DRAFT FINAL ENGINEERING EVALUATION/COST ANALYSIS FOR AREA OF CONCERN J
AND R (AOC J AND R) AND SOLID WASTE MANAGEMENT UNITS 6 AND 7 (SWMU 6 AND
7) FORMER NAVAL AMMUNITIONS SUPPORT DETACHMENT VIEQUES ISLAND PUERTO
RICO (DRAFT FINAL ACTING AS FINAL VERSION)

**Engineering Evaluation/Cost Analysis
for
Area of Concern J and R, and
Solid Waste Management Units 6 and 7**

Preliminary Response to Comments on *Draft Engineering Evaluation/Cost Analysis for Areas of Concern J and R, Solid Waste Management Units 6 and 7, Former Naval Ammunition Support Detachment, Vieques Island, Puerto Rico (CH2M HILL, August 2005)*

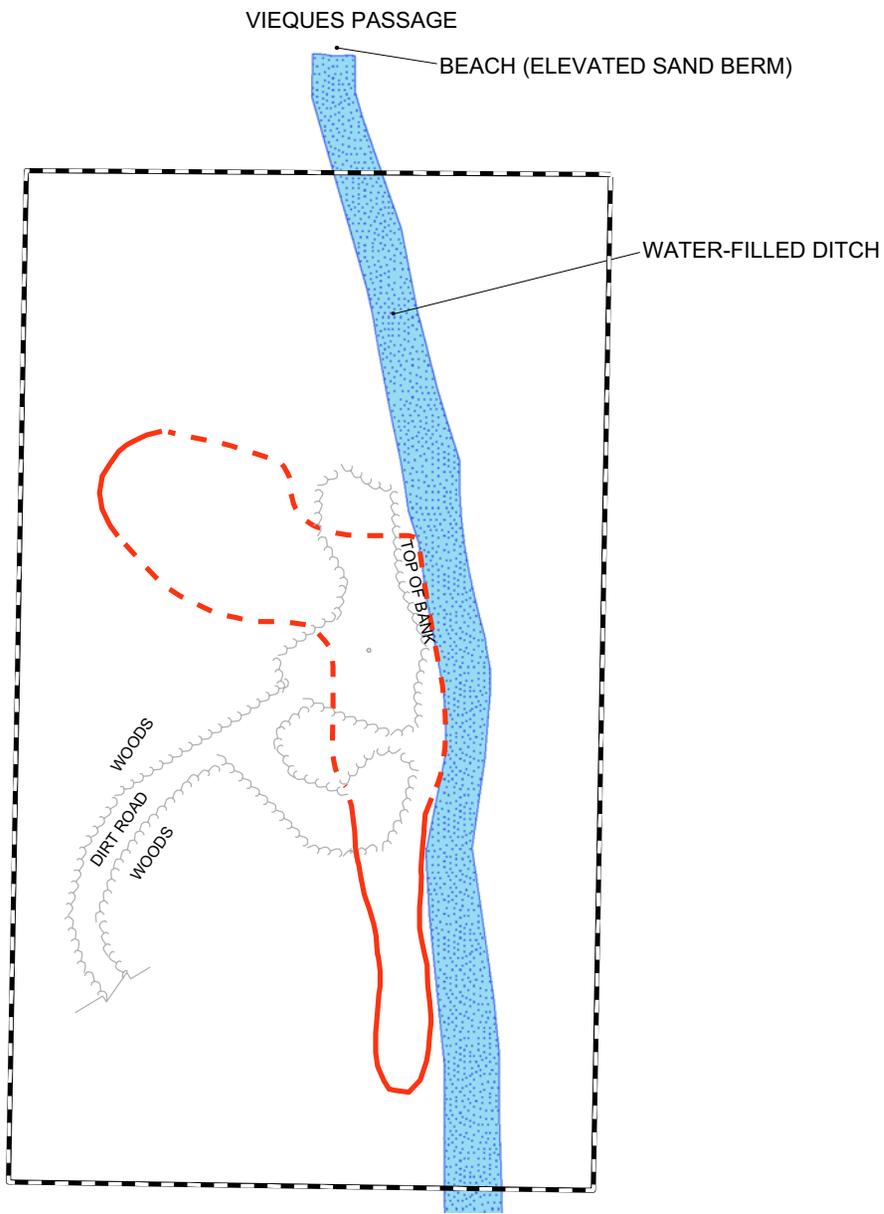
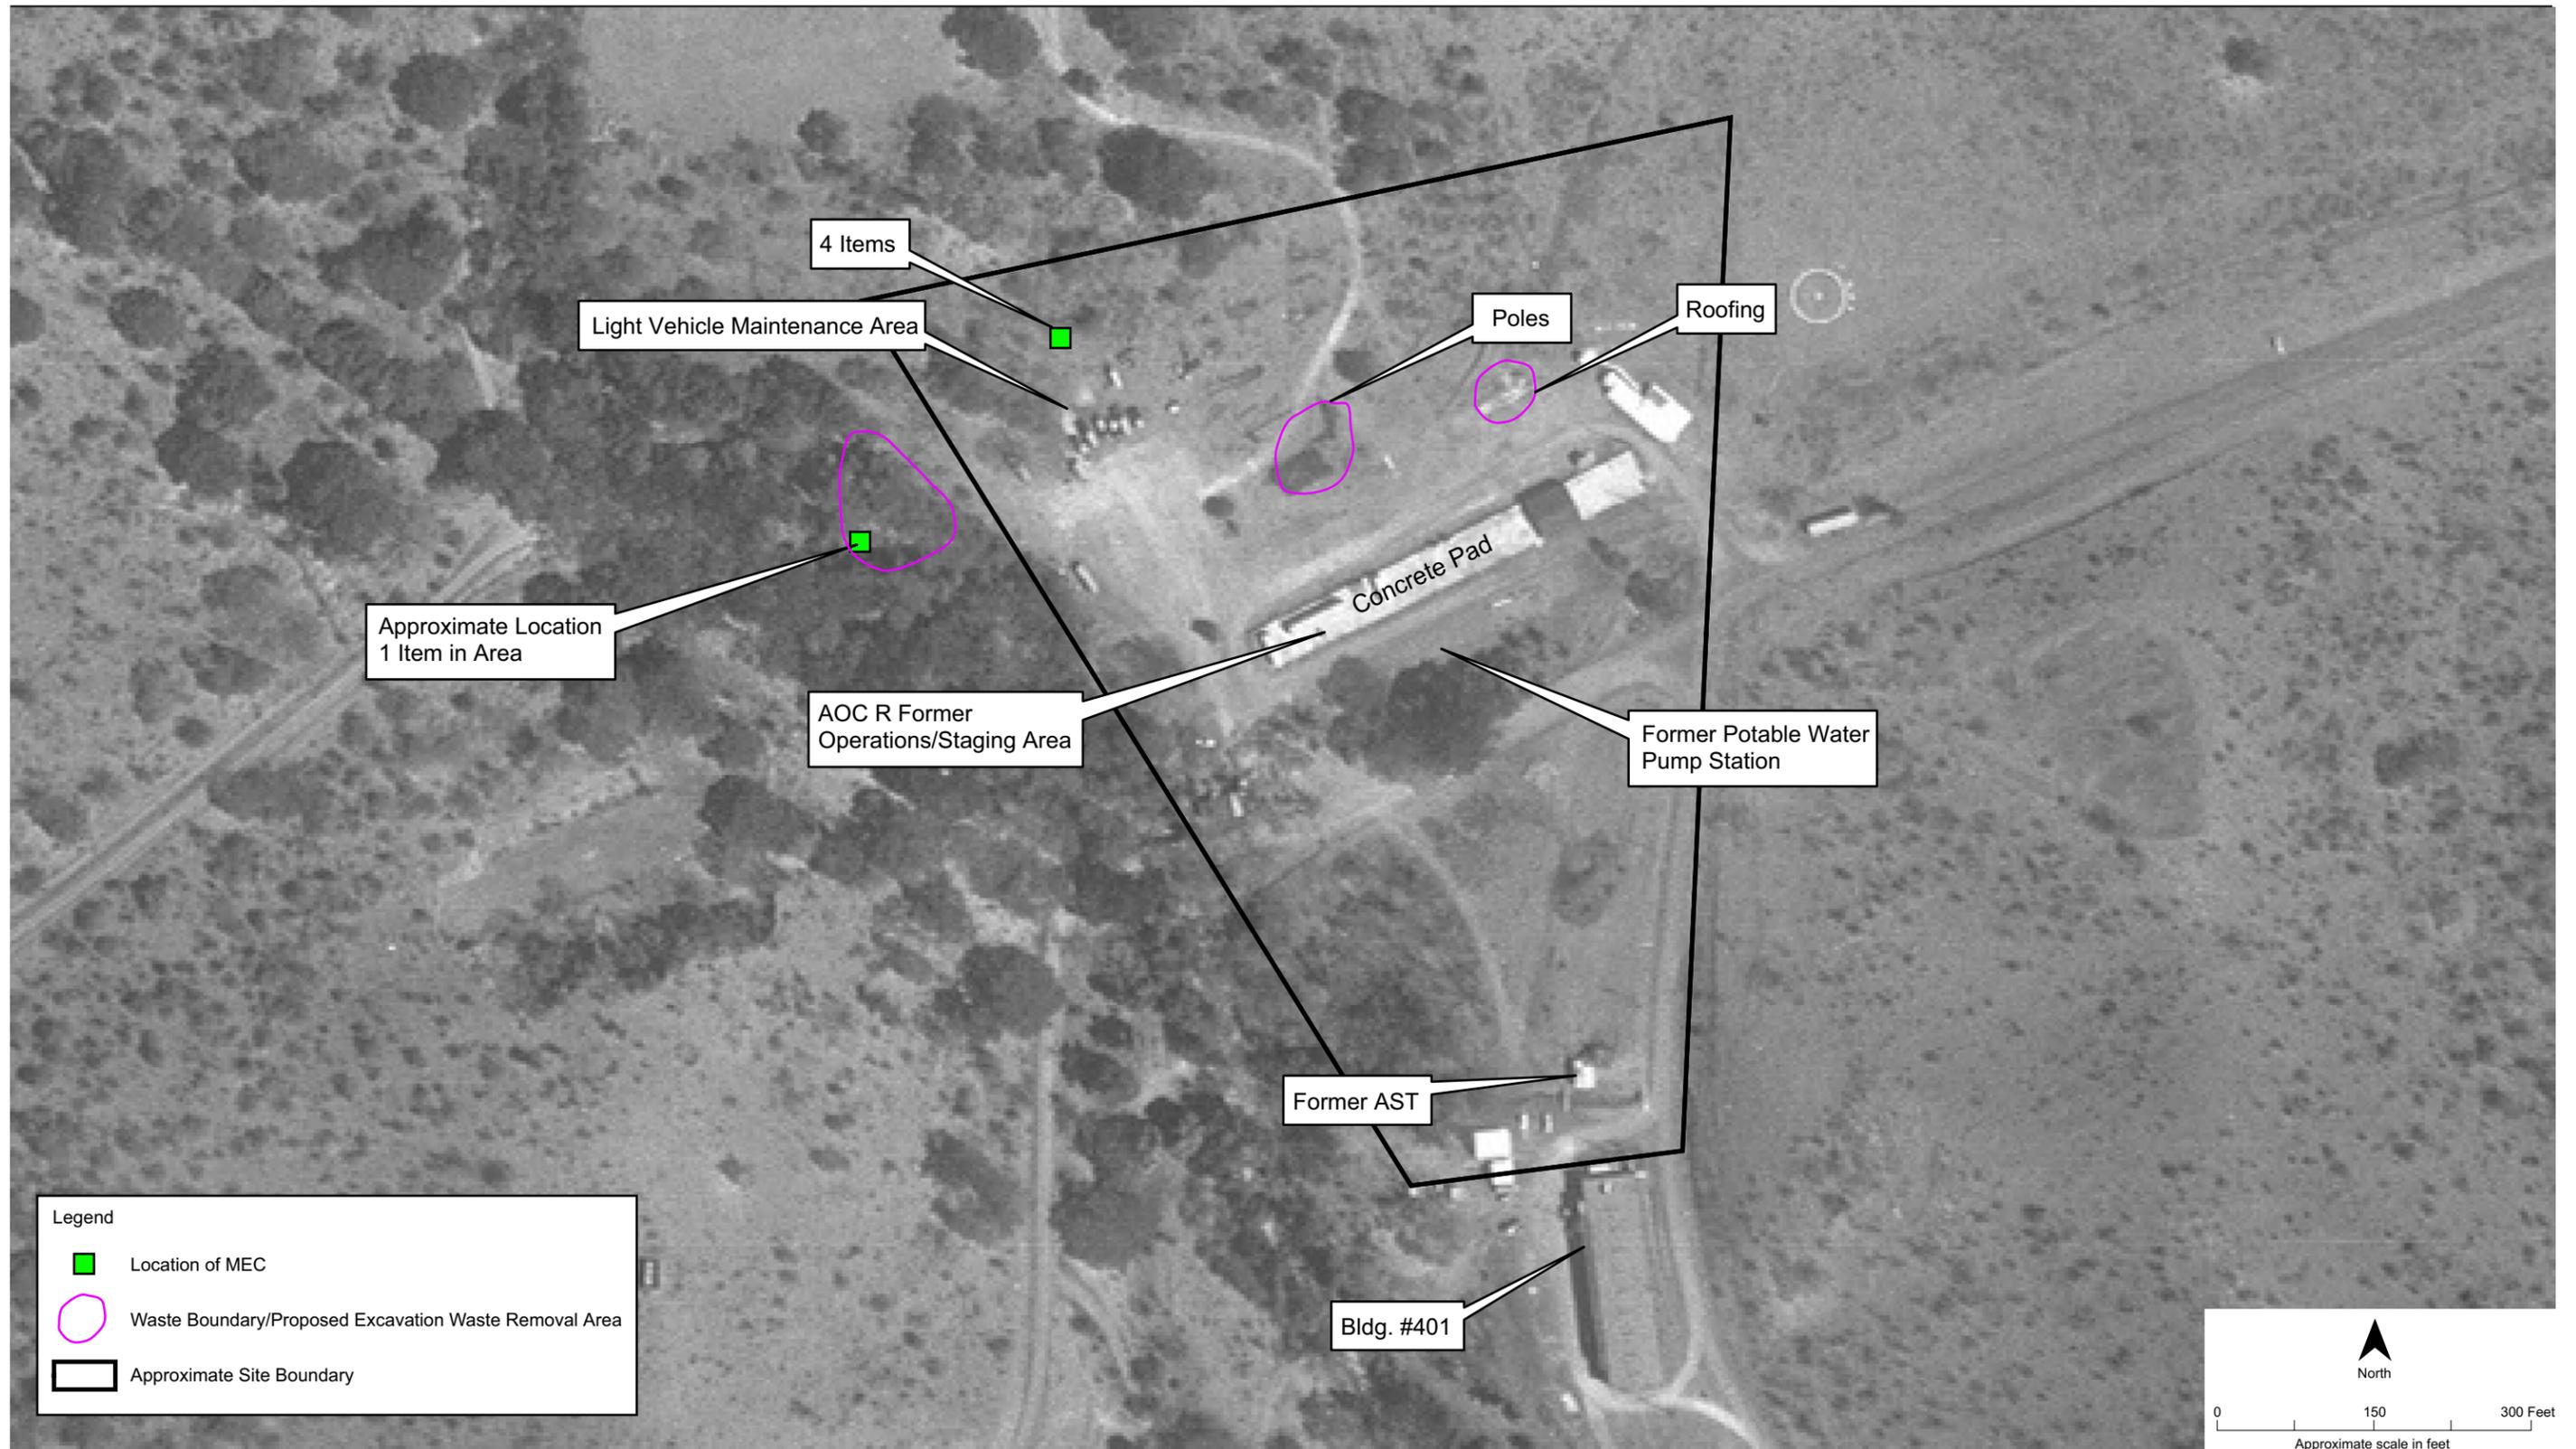
11. Section 3.1.3, Alternative # 3 - Excavation, Off-site Disposal and Site Restoration, page 3-2, and Table 3-2 Alternative 3 - Excavation/Restoration Details/Sequence: Please note that a sampling plan outlining how post-excavation samples will be collected and analyzed and how data will be interpreted should be submitted to EPA for review.

A removal action work plan is the planned next step in the removal process. The removal action work plan will identify the estimated removal action areas, confirmatory sampling protocol, and data evaluation procedure. Section 3.1.3, page 3-2, and Table 3-2 will be modified to state a removal action work plan will be developed for regulatory review prior to mobilization.

Figure 3-3
SWMU6 Proposed Excavation/Waste Removal Areas
SWMU 6, Former NASD, Vieques, Puerto Rico

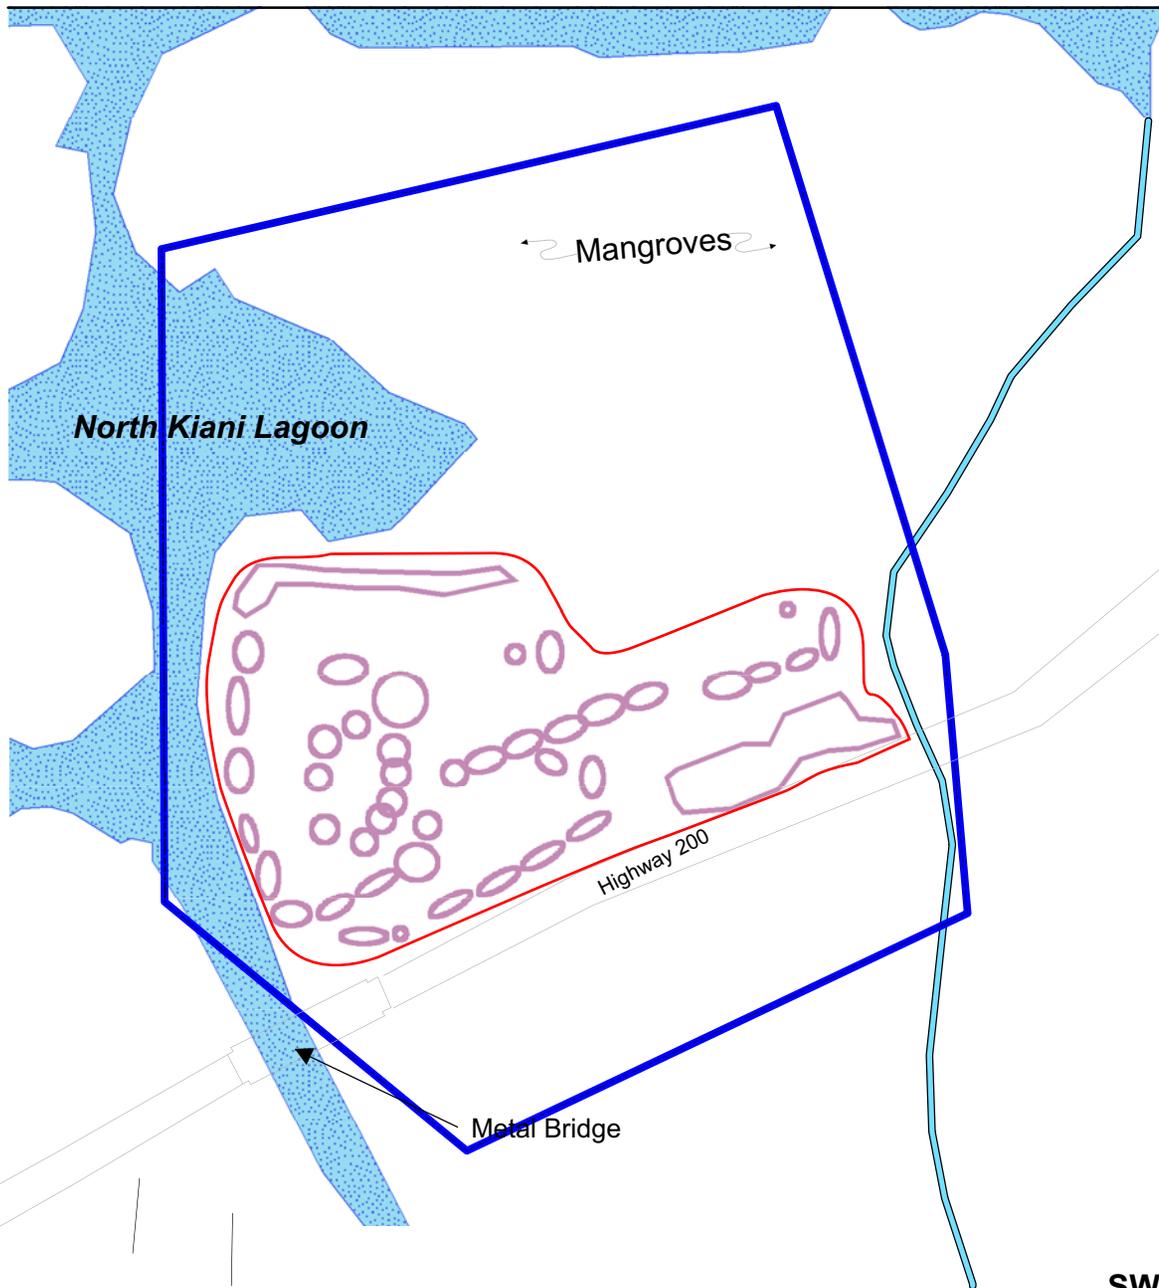
13. Figure 3-3, SWMU 6 Proposed Excavation/Waste Removal Areas: The site boundary shown in this figure does not extend to the south of Highway 200 as shown in Figure 1-5.

Figure 1-5 is the historical site boundary associated with SWMU 6. Figure 3-3 shows the area for excavation/waste removal, based upon site surveys to delineate the location of waste piles. Figure 3-3 better represents those areas where waste/debris piles are present within the historical site boundary. To clarify that the areas shown in the figures were primarily for cost estimating purposes, the following sentences will be added after the first sentence of the first full paragraph on page 3-2: "It is important to note that the removal areas shown in these figures are approximate and were used primarily to estimate the removal costs. The actual removal areas will be based on the extent of the debris areas identified during the removal."
